FDOT Permit 2023-K-799-00029 Request for Additional Information No. 1

WORK DESCRIPTION:

City of Madeira Beach: It is the City's desire to dredge the area within John's pass to restore access to adjacent marinas and remove the excess sediment from the Pass. Dredging is proposed on the northern shoreline east of the Gulf Boulevard Bridge.

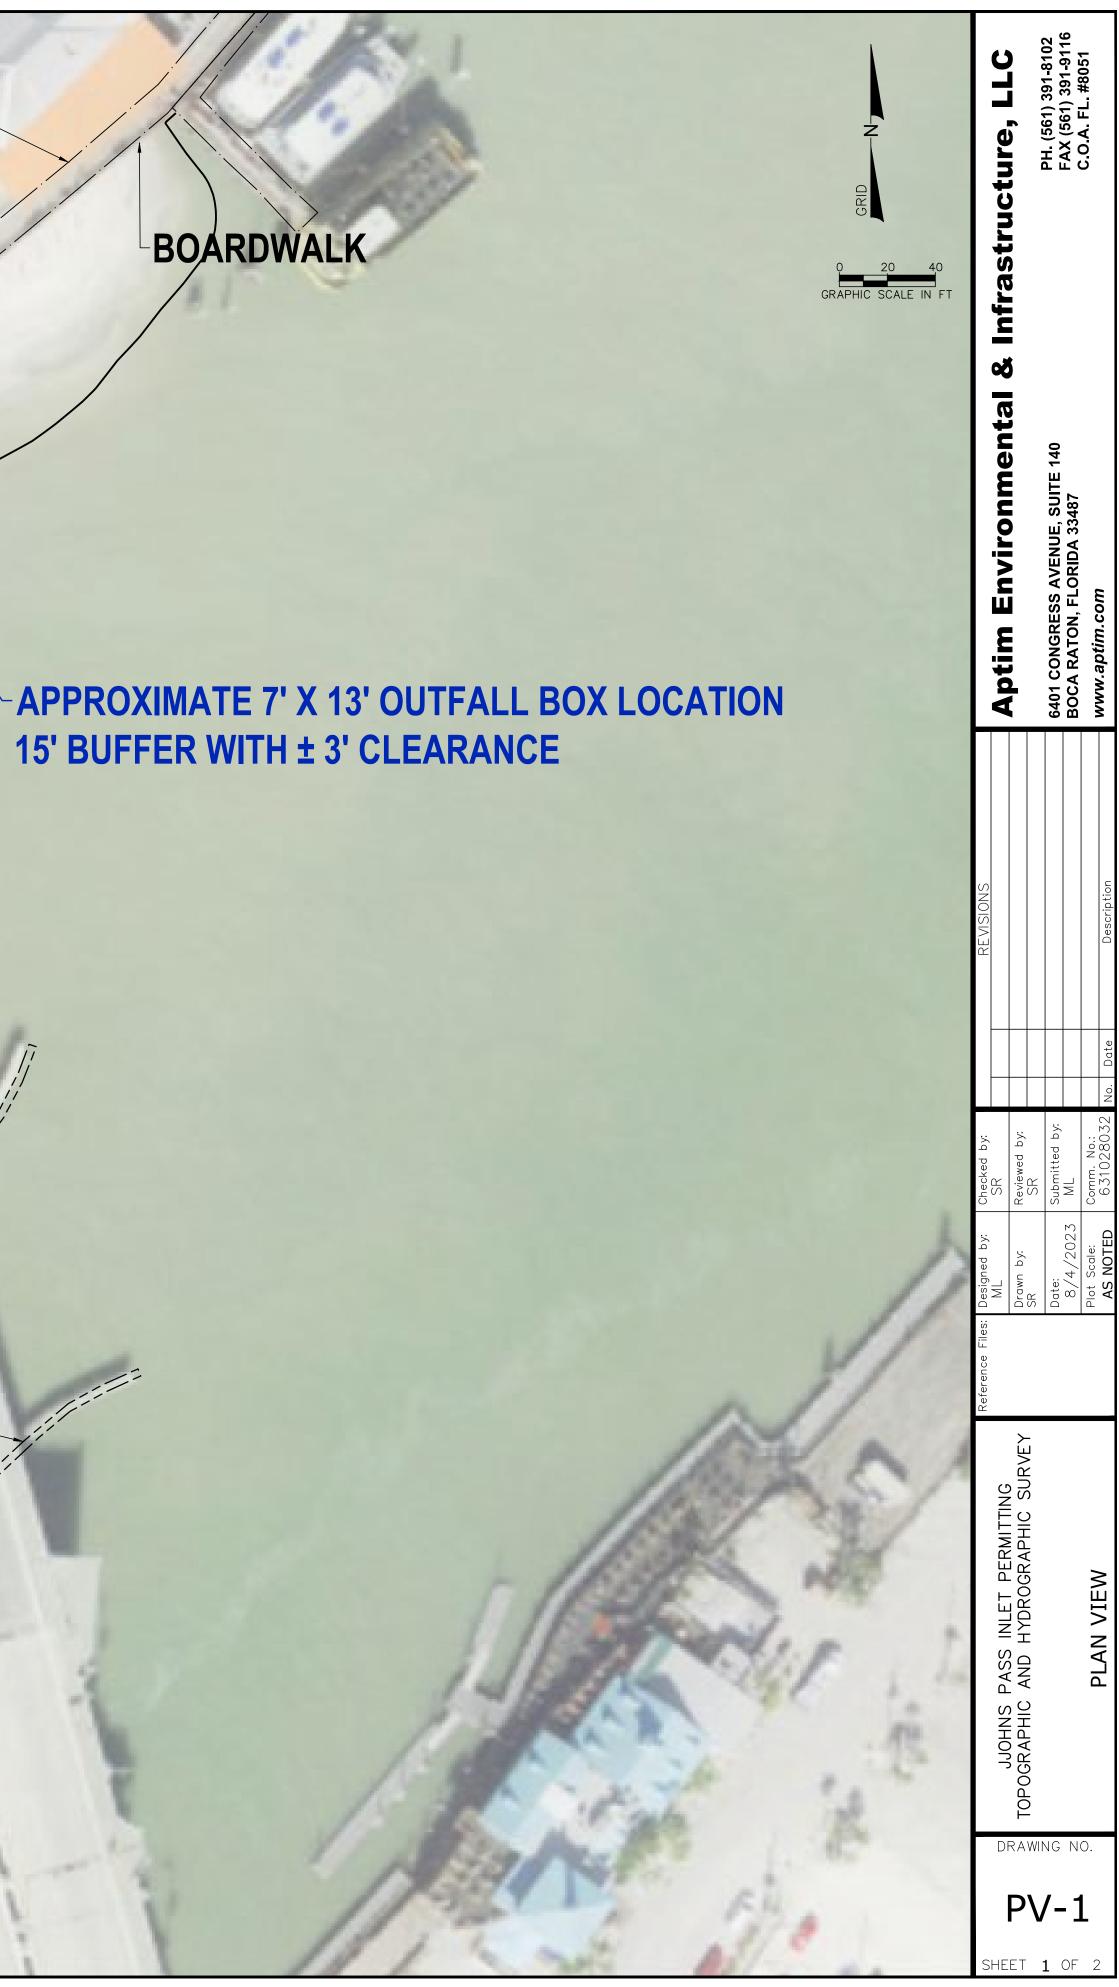
1. Provide a map identifying "Equipment Staging Areas".

See attached drawing, PV-1.

APPROXIMATE STAGING AREA (PERIMETER/ SAFETY FENCE)
